Product/Process Change Notice (PCN)

PCN_WS-HP_Cover_Change_20131126
Product Affected: WS-HP
PN : 416 131 160 802 & 416131 160 804

416 131 160 8xx

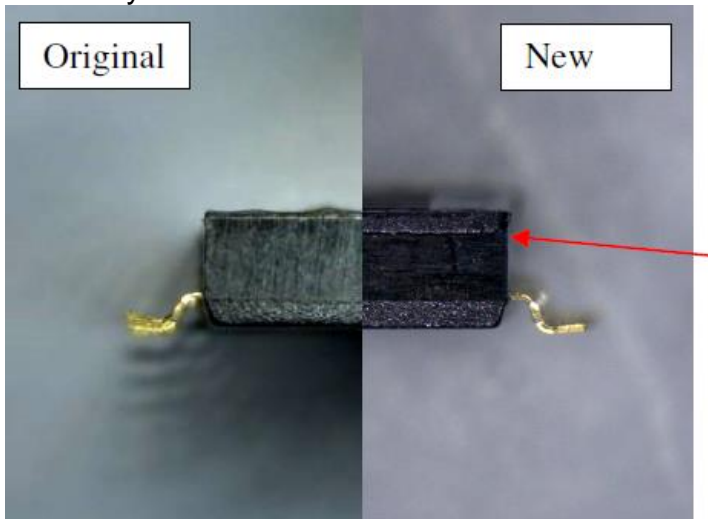
1. Purpose of change :
Due to massive production, a new tooling was in view and is now ready to use.
2. Actions :
Tooling/moulding was re-built. There is no change of dimension or specification implemented and function are not affected. For more details change, please see below photos.
3. Revise Specification
No specification required to be changed.
4. Cause this is a continuously improvement, therefore, the old version of the product is still available. Both versions can be sent out to customer until the old version is complete sold out. New product is available from : Lot number 254020071408000.
